# ELECTRO INDUSTRIES - FIELD SERVICE BULLETIN

Bulletin Number 1110 Date January 9, 2008

Product Name WF-EZ3 (WF6704EZ3 Replacement Board)

WF-EZ3  
(Board Rev.B after 09-17-07)

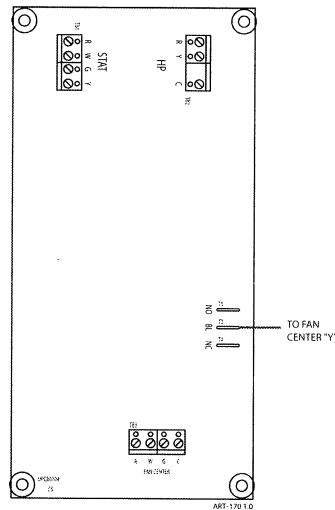
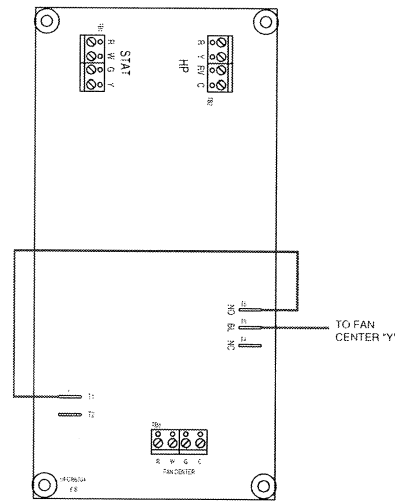
An update was made to the WF-EZ3 board in August eliminating the need to add a field jumper wire between T1 and NO terminals when using a variable or multi-speed blower. In the past this added jumper was necessary to get the fan to go to high speed when in electric mode. This update allows high speed fan without having to add the jumper. The problem is when adding this jumper wire to the latest board revision it will cause voltage to feed directly to the heat pump Y terminal, thus causing the furnace and the heat pump to operate at the same time during a heat call.

Please note this update also corrects the issue of certain furnace control boards locking out when "Y" and "W" are both present (reference Field Service Bulletin 1103).
